6.4 LATE ITEM - PLN15/1176.02 - 2 Gough Street, Cremorne

1. This report provides Council with an assessment of planning permit application PLN15/1176.02 being an amendment to Stage 2 of the overall Nylex Silos redevelopment. The subject site is 2 Gough Street, Cremorne and recommends approval subject to conditions.

Ward: Melba Ward
Proposal: Amendment to the endorsed plans and permit conditions of PLN15/1176 including:

Figure 21 – proposed ground floor building B6

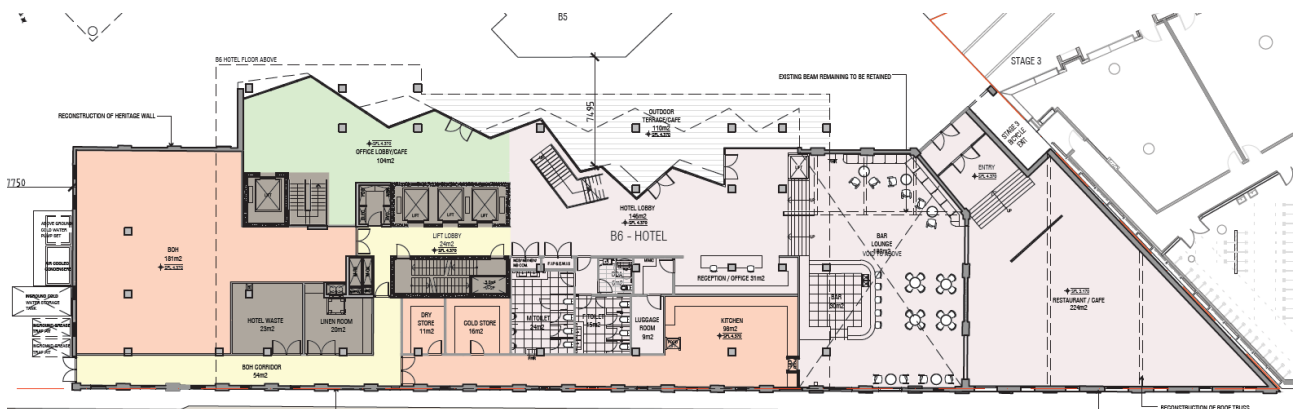
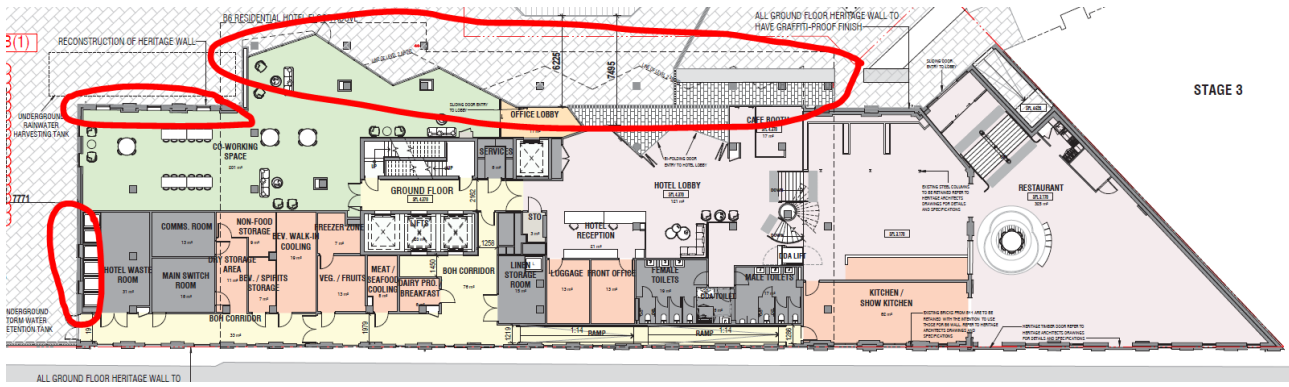
221. The ground level northern façade has been modified to regularise the staggered ground level glass line and improve the previously blank walls presenting to the internal courtyard (required by condition 1(q)).

222. The changes are shown in red above are either consistent with the conditions of the permit or are a minor design changes which simplifies the irregular glass line of the façade, both changes are considered to be acceptable changes.

Figure 24 – proposed south elevation – winter garden detail

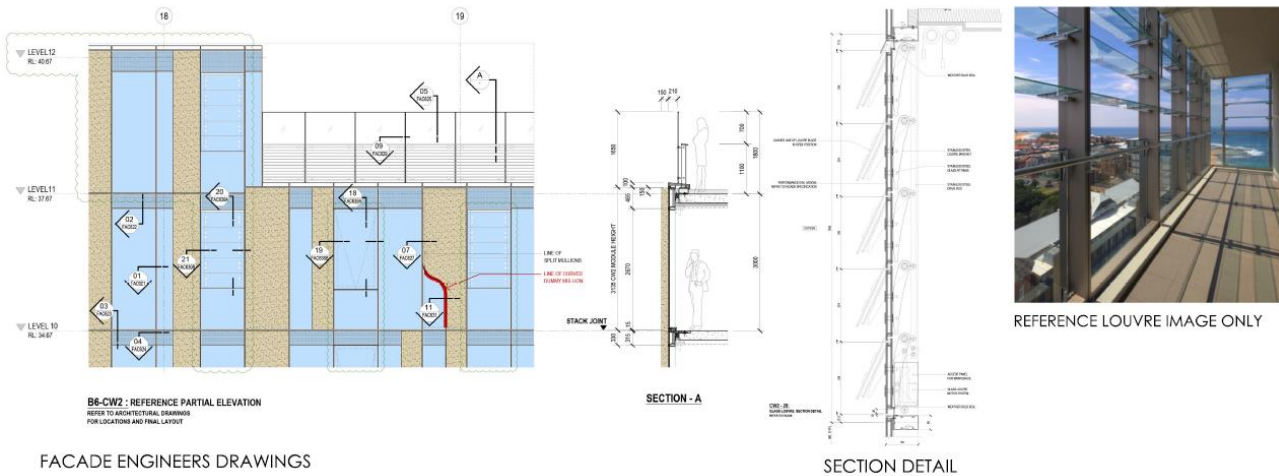
224. The insertion of these winter gardens improves the internal amenity of the hotel rooms while maintaining a level of acoustic insulation as these hotel rooms interface with freeway.

225. Greater design detail is required to ensure consistency in the façade system, a sketch plan has been provided by the permit application and this will form a condition of the amended permit.

Figure 26 – previous part ground floor (not endorsed) Figure 27 – proposed part ground floor

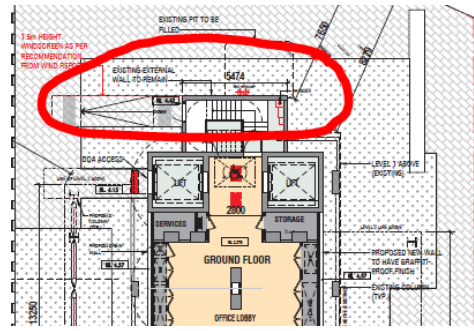
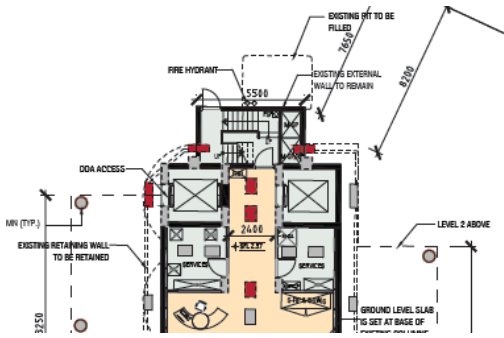
228. The ground floor presentation to Gough Street is proposed to be varied with the relocation of the access point from Gough Street to the western side of the building with the addition of a ramp and a 1.5m screen designed for wind mitigation purposes (see images below).

229. This change is marginal and subject to a condition detailing the wind mitigation screening device, this change is acceptable.

Figure 28 – proposed part west elevation

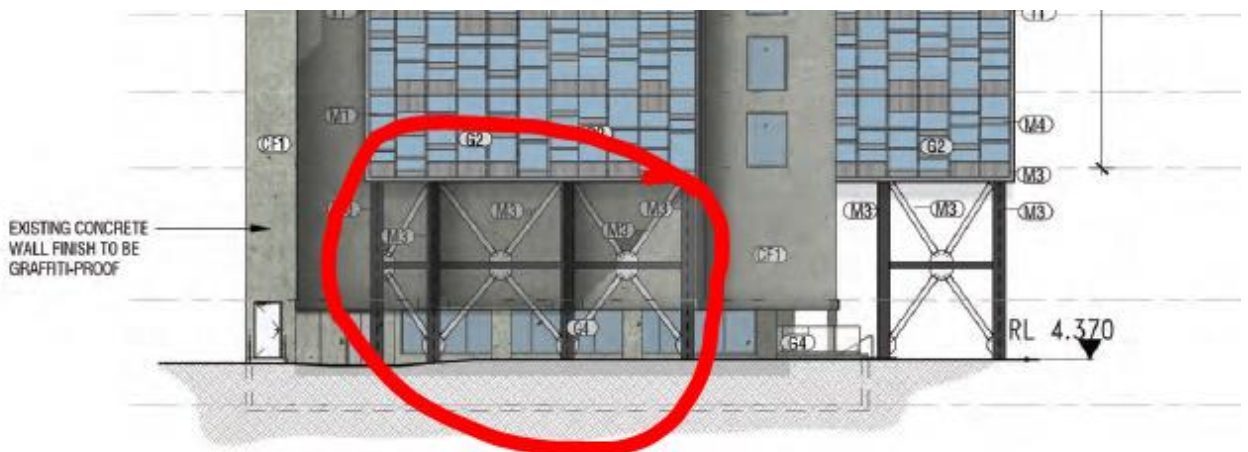
- (a) *I agree the new braced columns have been installed for structural support and restraint of the new upper level additions in order to comply with current legislation.*
- (b) *However, the new addition work appears to rely somewhat on its structural stability being connected to the existing silo which should not be the case.*
- (c) *.....*
- (d) *Confirmation should be confirmed that the new addition works is completely self-supporting for wind and earthquake loading with no reliance on the silo structure.*
- (e) *Further comment without structural plans and computations that another competent structural engineer should assess.*

232. The need for this bracing has not conclusively been dealt with and requires further consideration, the existing condition will remain and be amended to reflect the additional bracing of this building proposed along the western elevation.

Figure 31 – proposed North elevation

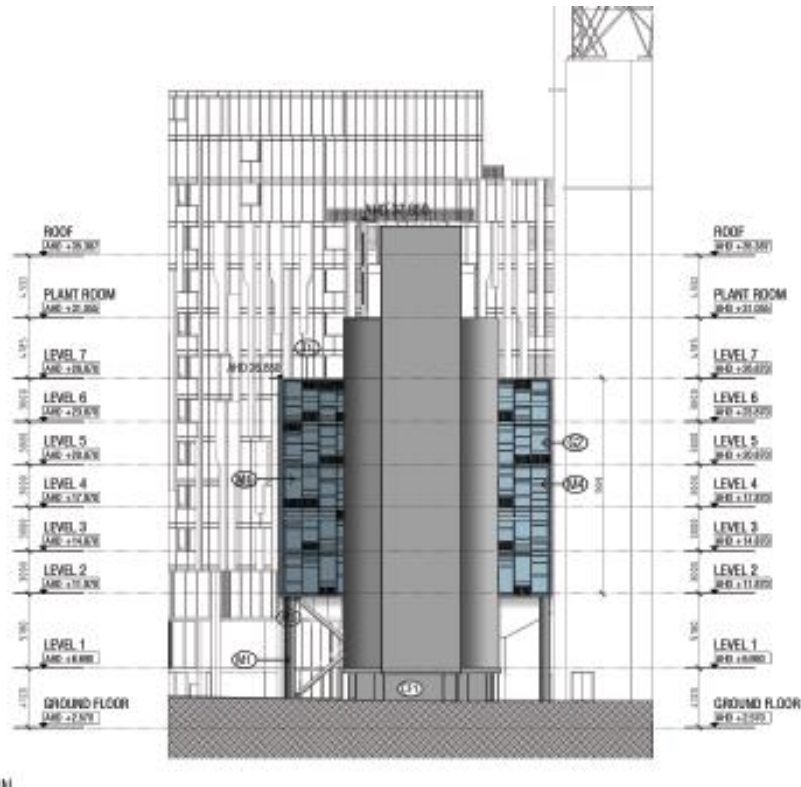
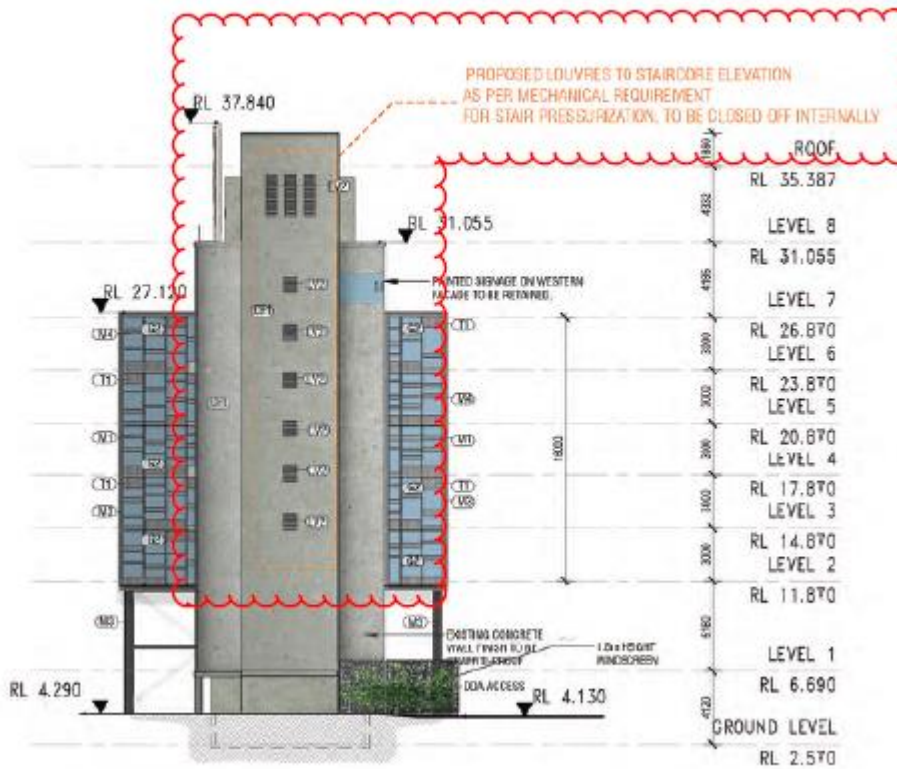
235. Louvres are proposed to be added to the northern end of the silos as per the requirements of the mechanical engineer.

236. As evident by the existing images of the silos, these openings already exist and use of these is consistent with the former industrial use of the structures, a view that is shared by Council’s Heritage Adviser.

Figure 34 – proposed part ground floor

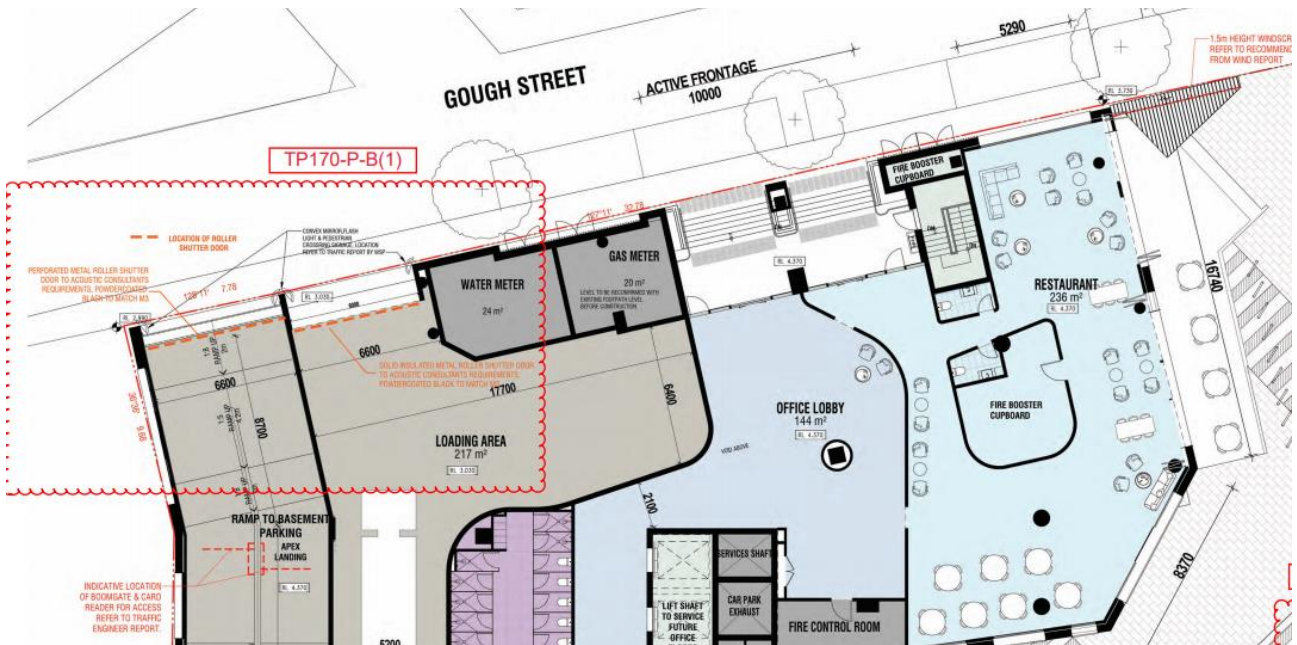
- 242. Forming part of the amendment was a response to this condition which outlined why the servicing was required to be located to Gough Street and that moving this internal to the site was not necessarily possible.
- 243. Council consultant urban designer along with officers raised concern with the extent of blank frontage to Gough Street and that the development needed to better respond to this interface.

Figure 36 – proposed part ground floor

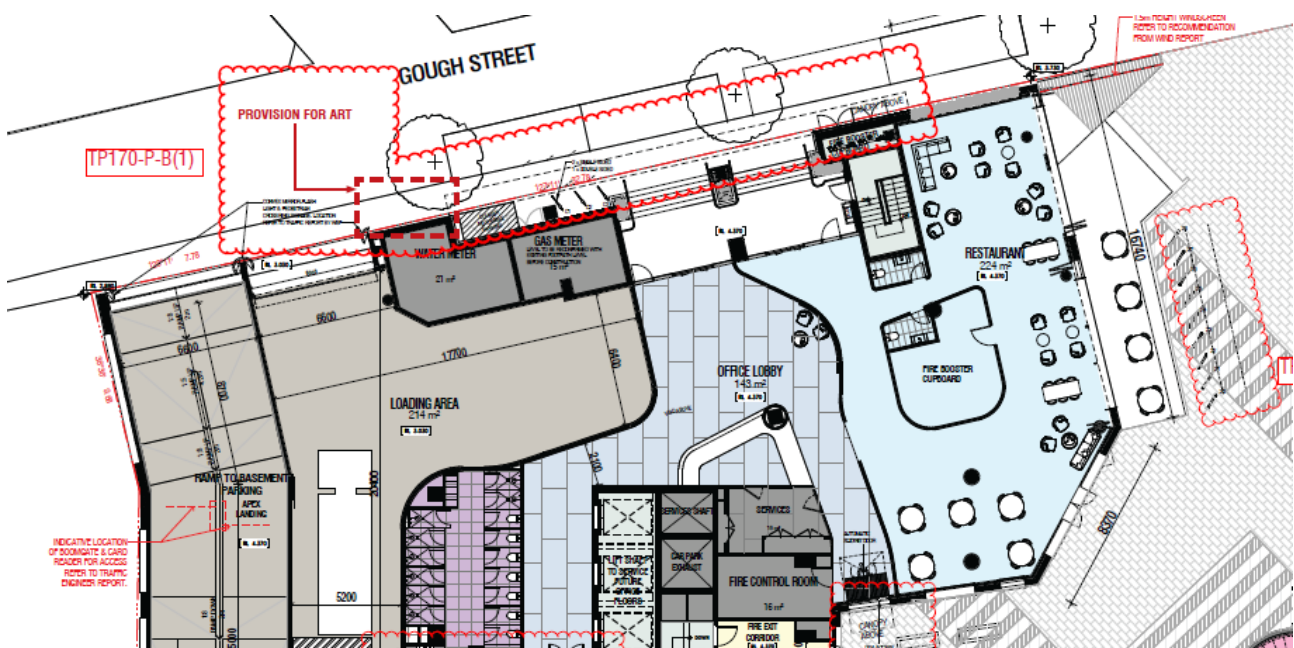
244. In response, the S57A plans have sought to address this concern by modifying the design presentation of the services element through use of less dominate materials and have proposed to incorporate a canopy to mark the entry to the building and landscaping to improve the presentation to the street.

Figure 40 – proposed part ground floor

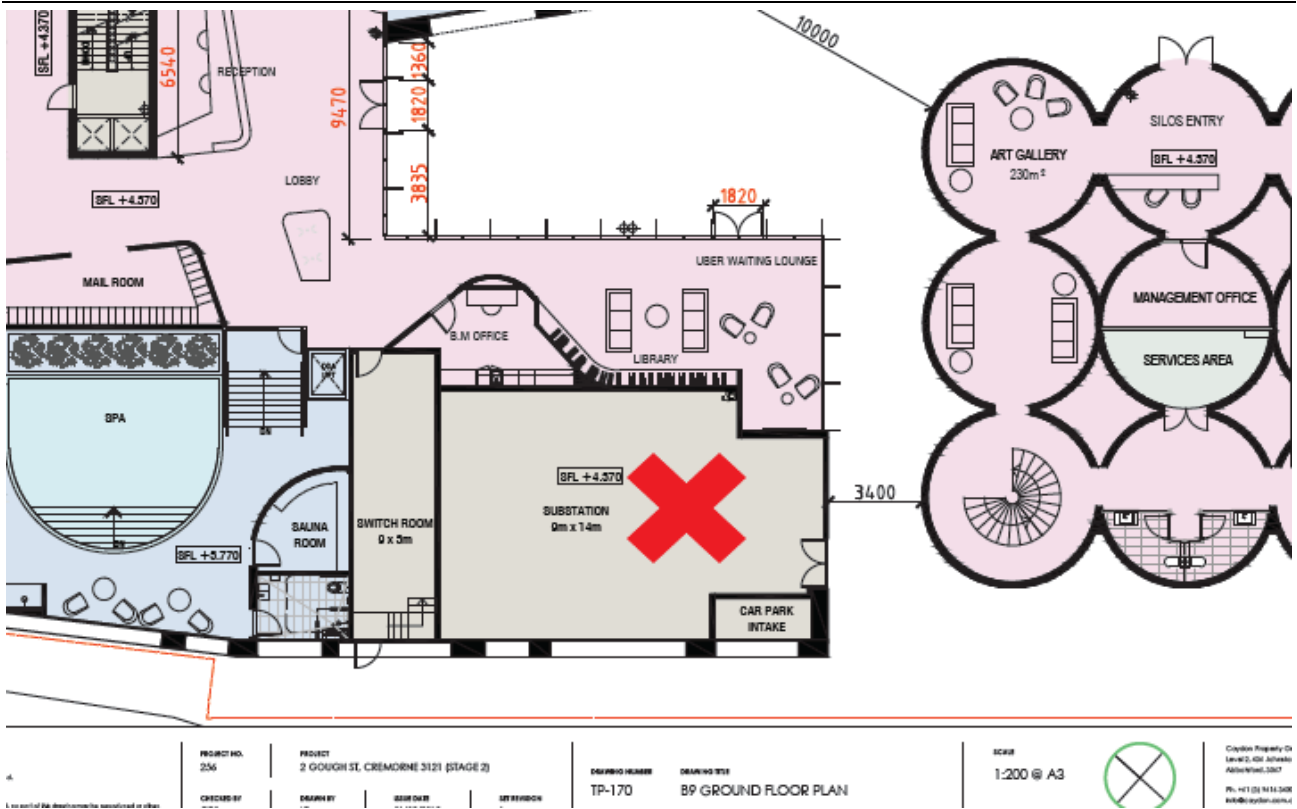
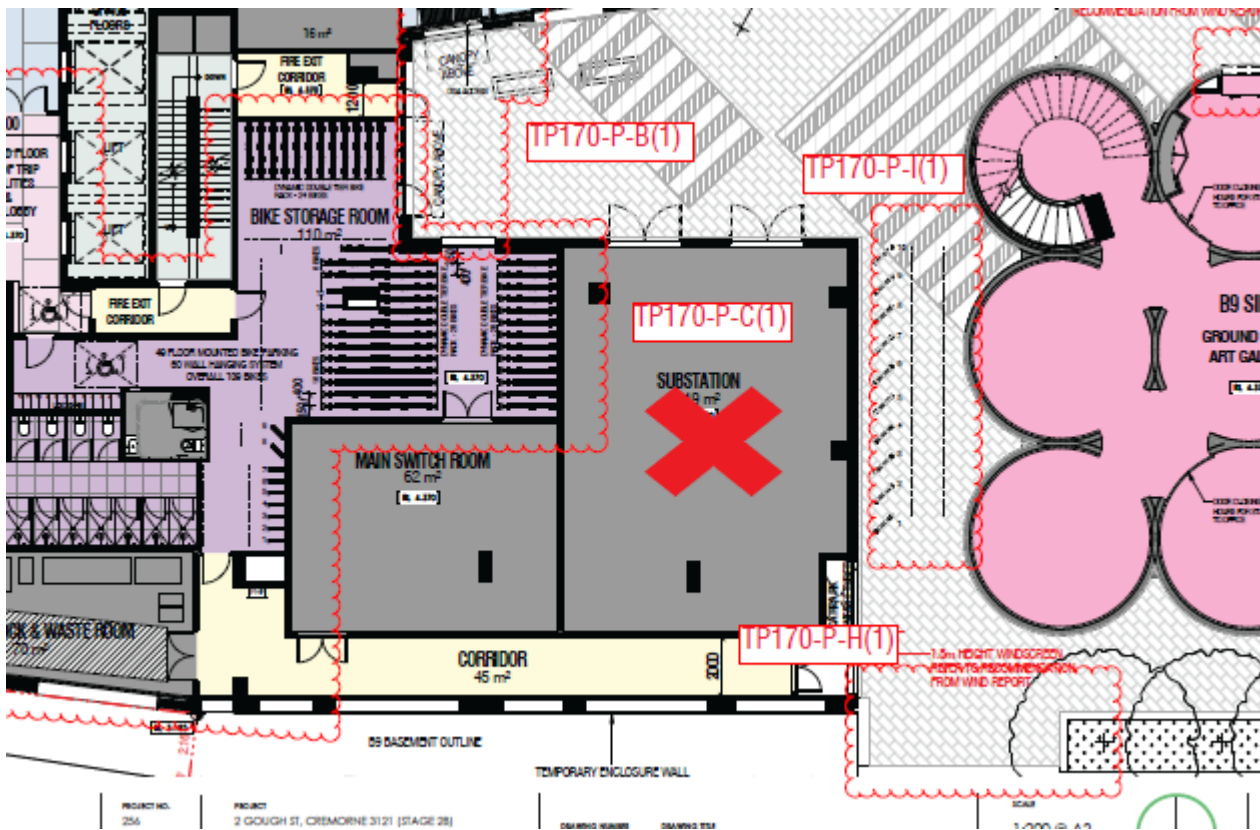
247. A substation within Building B9 has always been proposed with previous plans showing this located proximate to Harcourt Parade with the access to the substation located to the side away from the main internal landscape square with the front of the substation sleeved with activated spaces.

248. The amendment seeks to relocate the substation further north and proposes the access directly orientated to the internal square.

Figure 42 – proposed south elevation

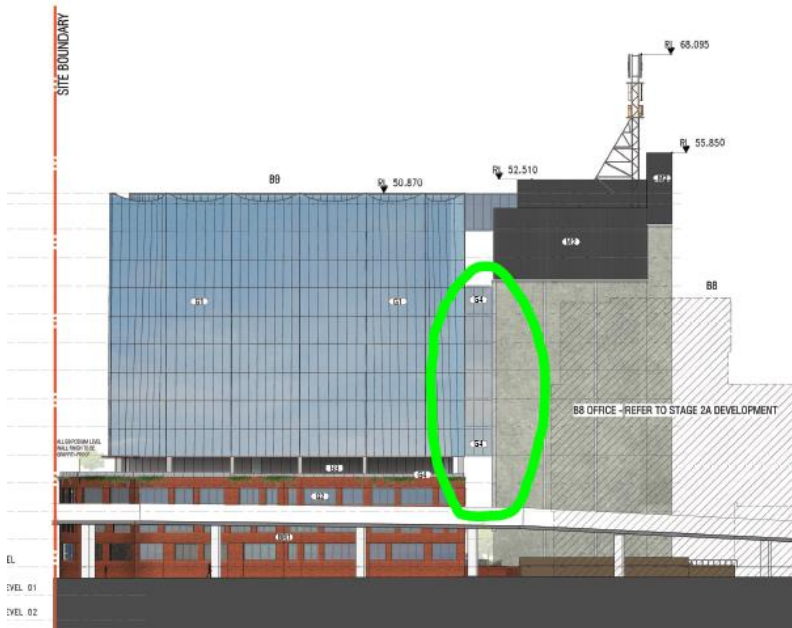
254. Council's consultant urban designer has raised concern with this element and suggests that the extent of the bridged diminishes the profile of the historic silo structure. He suggests the deletion of connection points at levels 4, 5, 6 and level 9 to enable the silos to be read in the round (see image below).

255. Conversely, Council's Heritage adviser is satisfied that the bridge connections are reasonably obscured from direct views.

256. Officers agree that the extent of connection between the two structures appears excessive and dilutes the presence of the silos on site. However, officers do not agree that the extent of connection removal as suggested by Council’s contract urban designer is required. A rationalisation of these connections needs to be made to ensure the silos are read as a stand alone feature and are not absorbed into the bulk of the new building.

Figure 47 Proposed – Ground floor

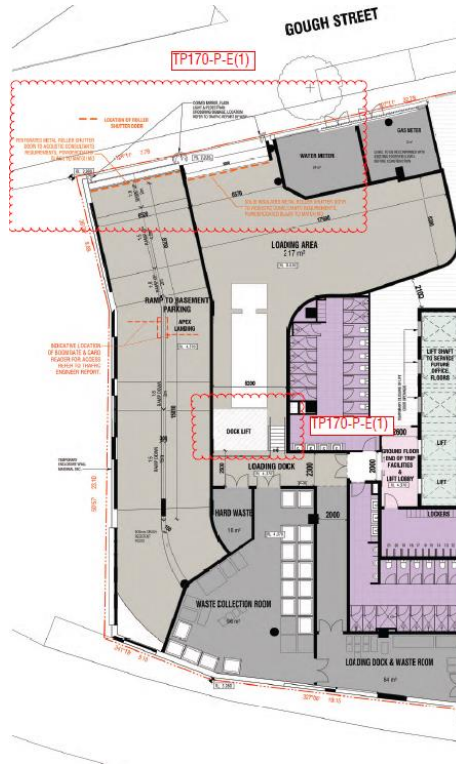
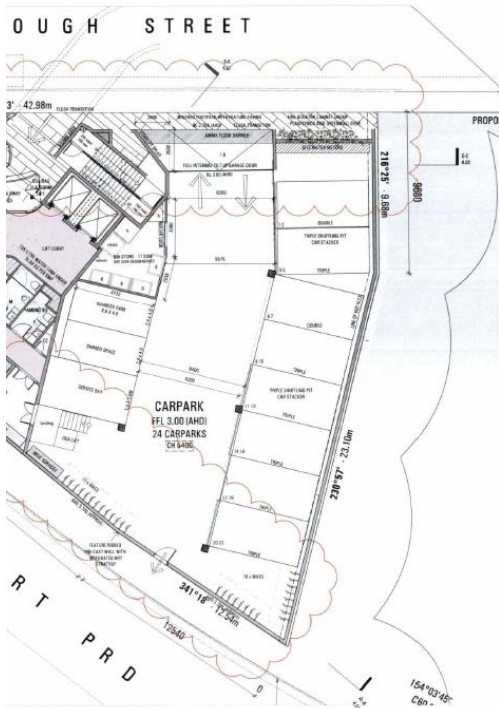
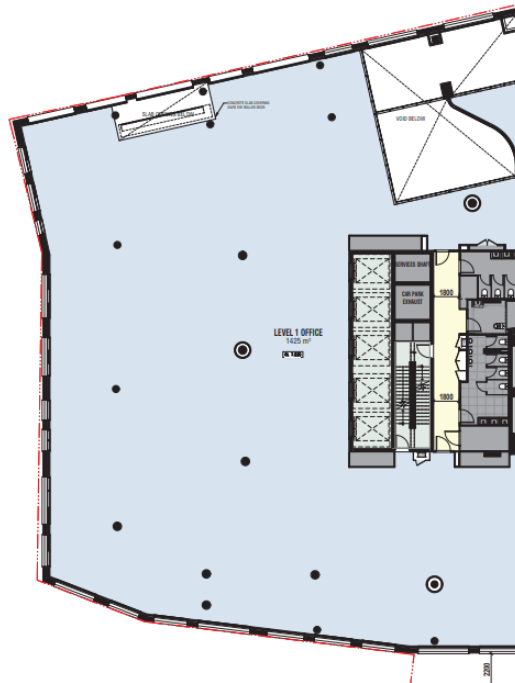
259. At ground level, the subject site locates a loading area immediately abutting the neighbouring property which similarly locates parking at this level.

261. It is acknowledged that openings on the boundary is not typically permitted as these have no rights to light and will need to ultimately be fire rated. The existing permit (condition 3(k)) requires these to be deleted and replaced with a suitably treated interface to avoid a blank wall. There is no consequence for the deletion of these window as light is available to the office space from windows to the north and south and therefore it is recommended that this condition stay.
